CITY OF OREGON CITY

CITY COMMISSION REGULAR MEETING

[8c.](#) AP 21-02 and AP-21-03: Adoption of Findings and Modified Conditions of Approval for Two Separate Appeals of the March 23, 2021 Historic Review Board Approval with Conditions of Planning Files GLUA-21-00001/ HR 21-00001 Through 21-00005 for Five Cottage Homes in the Canemah National Register District

Figure 2. Product comparisons: Smooth versus Textured (Cedarmill) siding

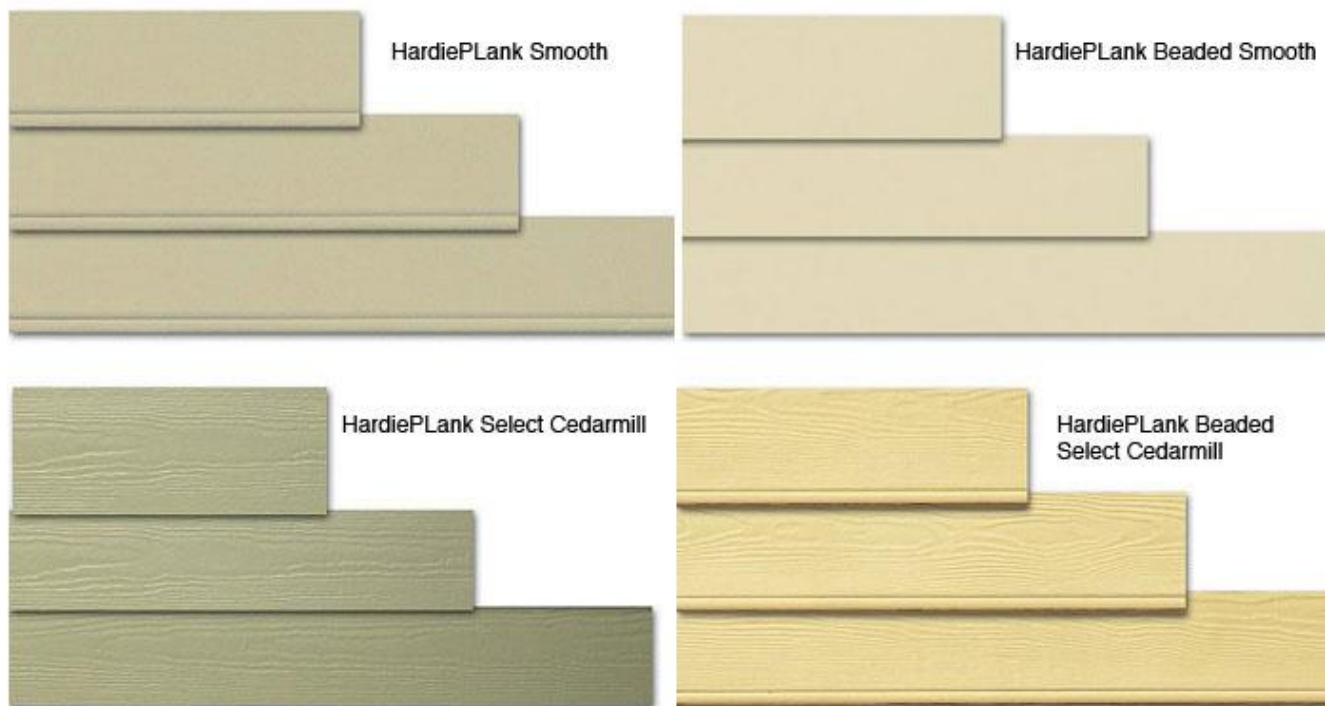
In other words, non-wood horizontal board siding that has “the appearance of horizontal wood siding” would be allowed.

The Appellant Christopher Staggs argues that the HRB’s finding that the textured fiber cement siding is “artificial and not consistent with the historic character of the district” is incorrect. Instead, Mr. Staggs argues, the “wood texture” cement board siding “is specifically designed to have the appearance of wood siding,” in addition to being durable and fire resistant. Mr. Staggs also cites the Design Guideline that states the vernacular style in Canemah “lacks rigid system of exterior detailing that makes it a

The City Commission upholds the HRB decision that the textured siding is not approved.

Figure 5. House #2 and surrounding grading and retaining walls in the original plans, versus the constructed plan.

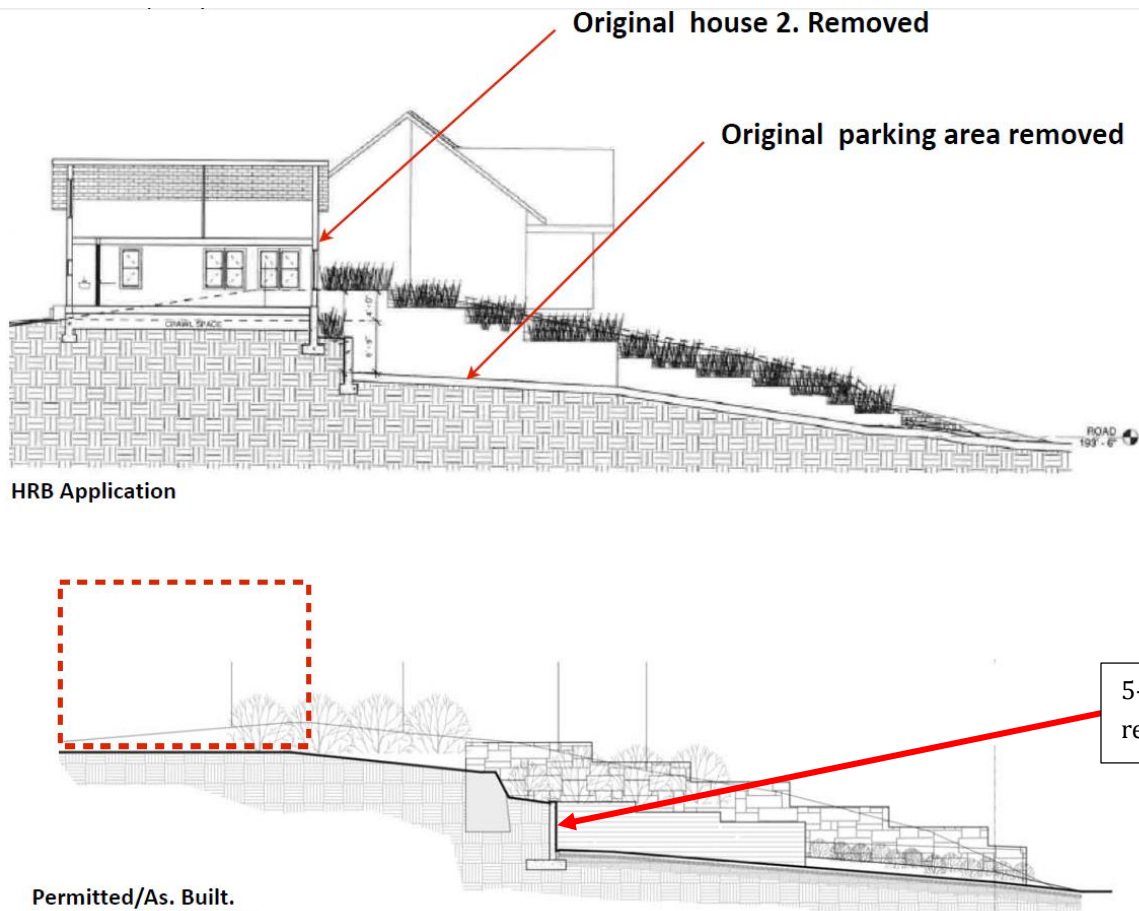
parking, the Applicant elected to eliminate the major site regrading in this area, leaving a larger open space area. To address the ground level elevation change, the applicant installed a 5-foot retaining wall behind House #1.

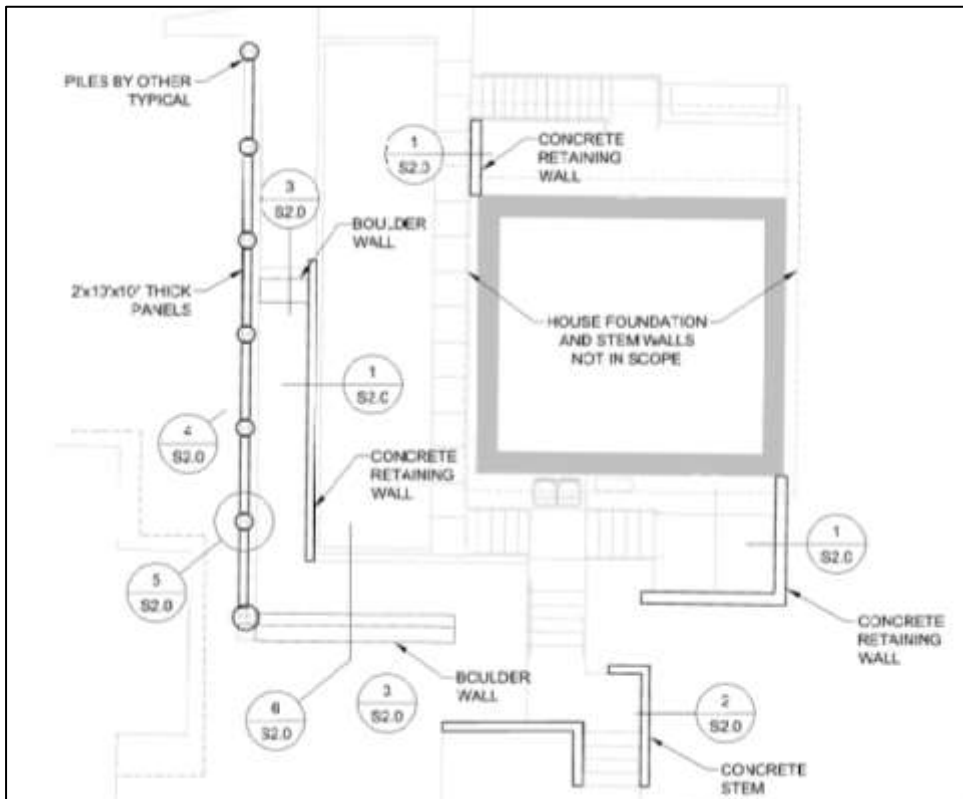
The skylights that have been installed are rectangular in shape with flat glass. They are placed on side-oriented roof slopes but are visible from the right of way, in violation of the condition. The skylight on House #2 does face 4th Avenue but is setback considerably from 4th Avenue, near the rear of the property. The skylight on House #2 will be at least partially obscured by trees planted on site. The skylights on House #5 are mostly obscured by vegetation, especially during the summer. House #4 blocks the view of the north facing skylights on House #5. Staff recommends that the skylights on House #2 and House #5 be approved.

While the skylights on House #4 do not meet the original condition of approval, staff advises that the skylights might be found to be appropriate due to their low profile, reasonable size, and location on side-oriented roofs. The use of skylights is a modern design and can be found to be compatible under these circumstances, especially on a structure with modest massing and height. There do not appear to be any possible actions that would mitigate for the visibility of these skylights.

Construction plans: retaining wall plan sheet

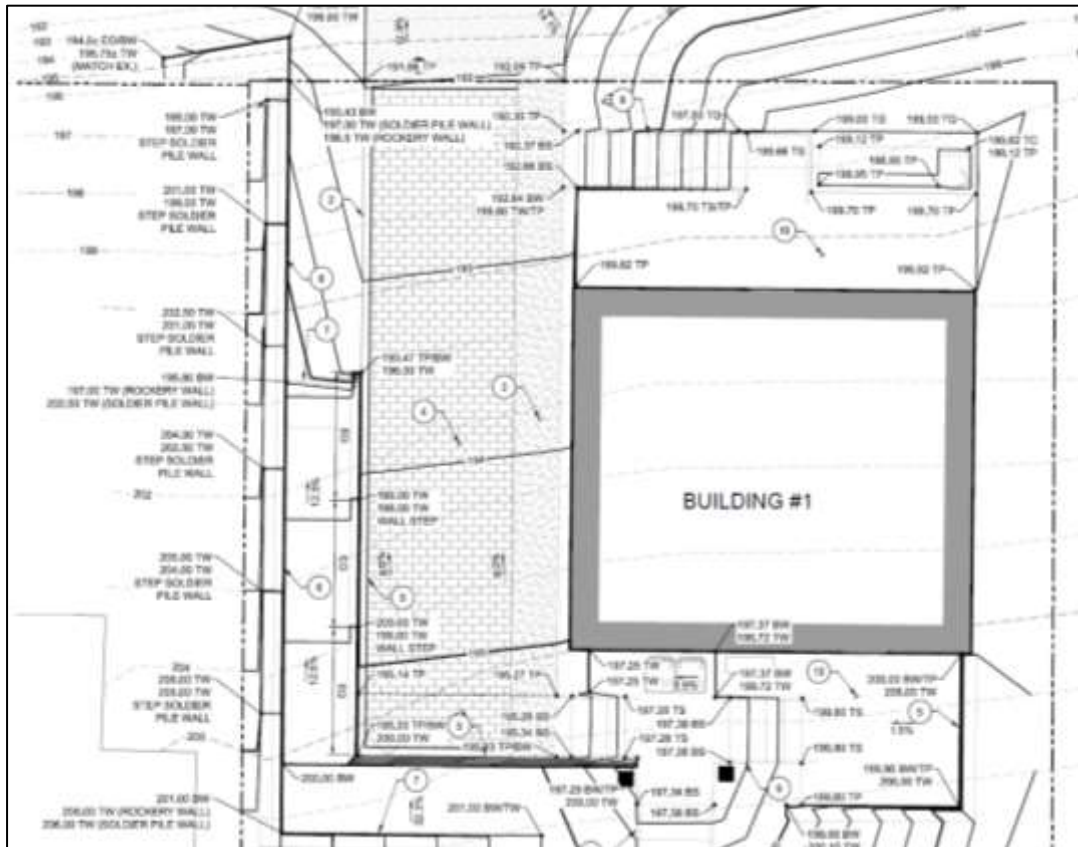
The design guidelines do not contain a specific height limit but rather call for minimization of retaining walls. The wall behind House #1 is in the rear yard and can be up to 6 feet in height based on general city standards. If the wall will end up being taller than 3.5 feet and the HRB finds that the height is not acceptable, the applicant could be required to add another wall to terrace the slope. Staff does not recommend any conditions of approval given that the wall is in the rear yard and proposed to be planted with vine coverage.

New Recommended Conditions

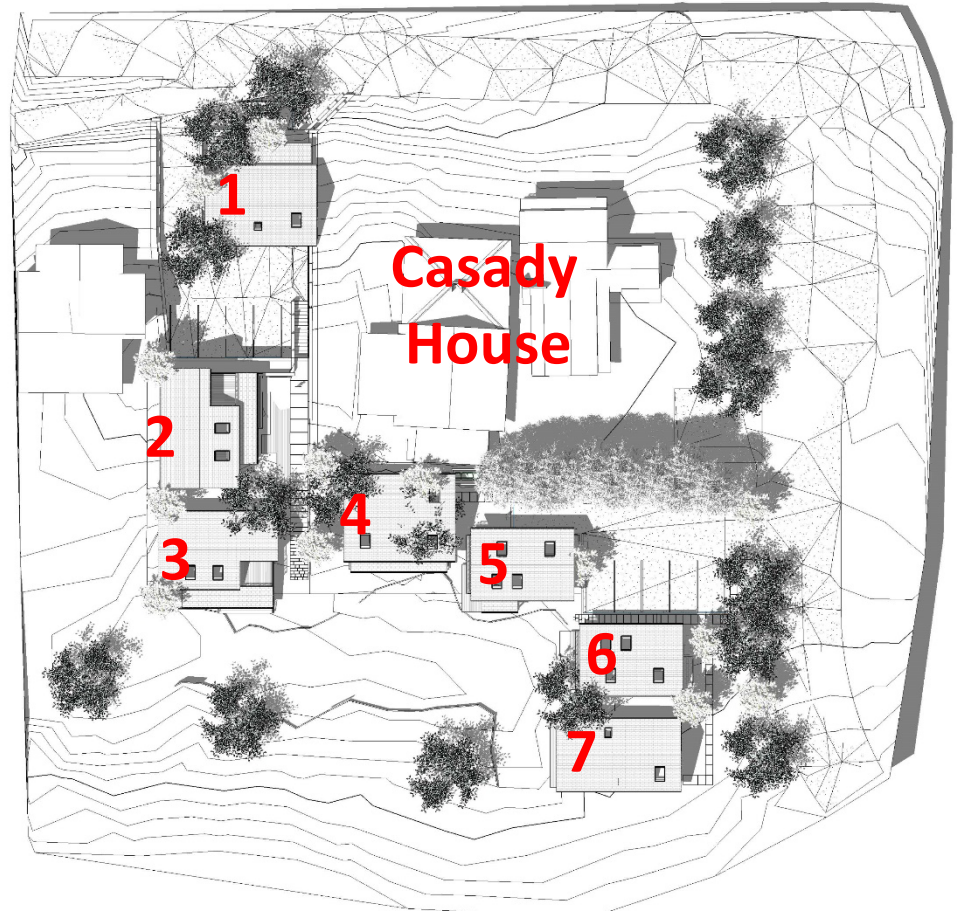
- Front of house #1
 - West elevation of House #1
 - Front of House #3
 - Front of House #4
 - North elevation of House #4
 - Front of House #5

4. The applicant shall plant native plants or seed mixes only within the wetland area and within 50 feet of the wetland boundaries. Plants or seed mixes with species not found on the city's native plant list are not permitted within the wetland, and any new plants within 50 feet of the wetland boundary shall be native species from the City's list as well. Non-native species within 50 feet of the wetland shall be moved to other areas of the site.
5. The applicant shall plant vines or espalier on the 5 foot retaining wall at the back of the parking area next to house #1.

EAST ELEVATION
Elevation Facing Miller St. / Right of Way

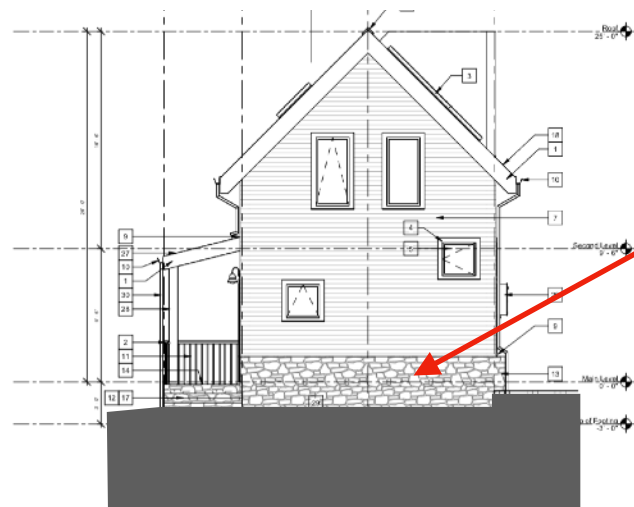
Window changed to square

SOUTH ELEVATION

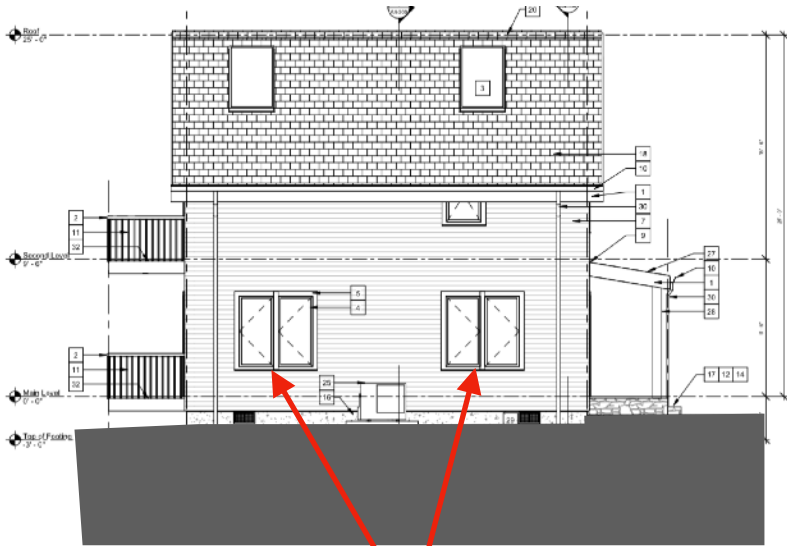
Skylight is not facing right of way and is not visible from right of way; historic guidelines reference - "skylights shall not be in roofs facing ROW"

All Homes - roof overhangs reduced; more consistent with Canemah homes than original application.

EAST ELEVATION
Elevation Facing Miller St. / Right of Way

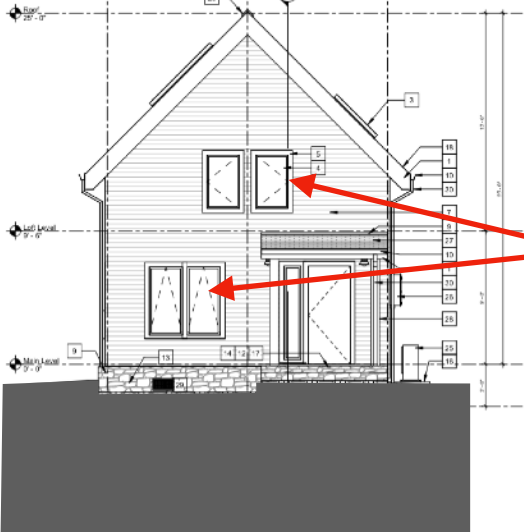
Window to be added to this elevation

Original HRB Application - Site Plan

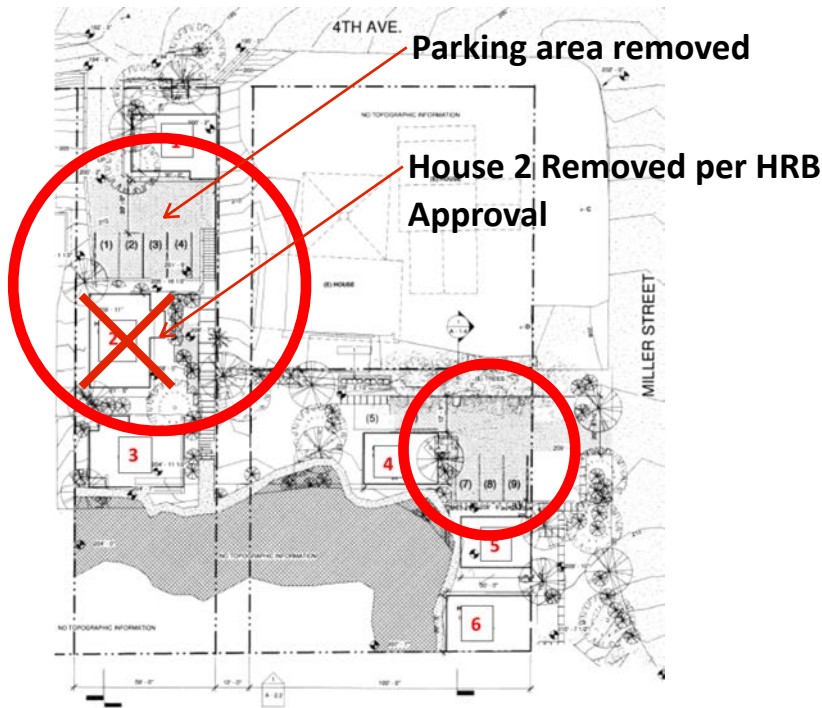
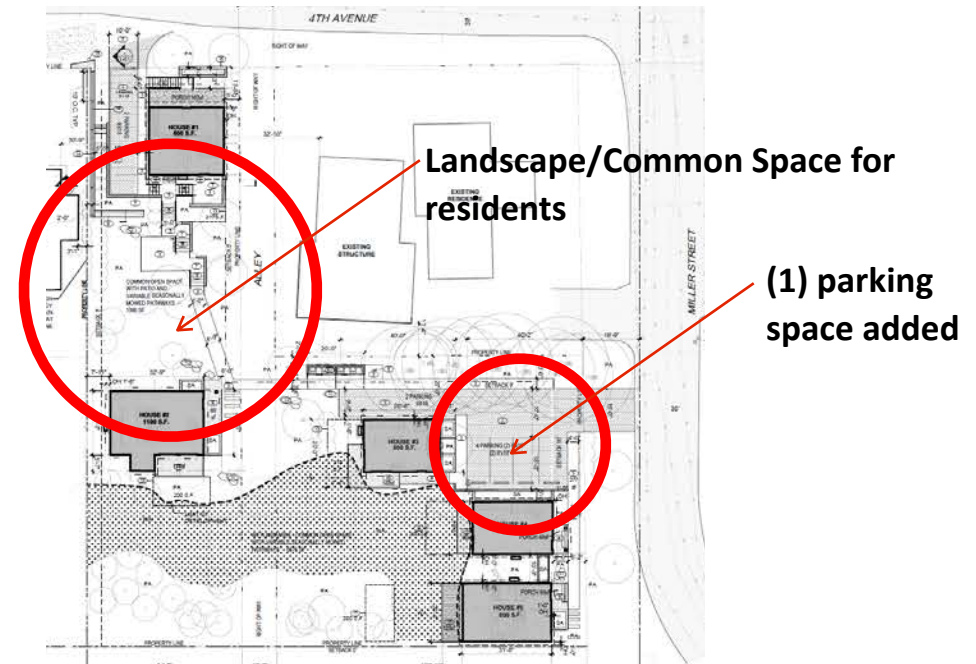
Parking Area removed behind house 1. One space added by house 4.
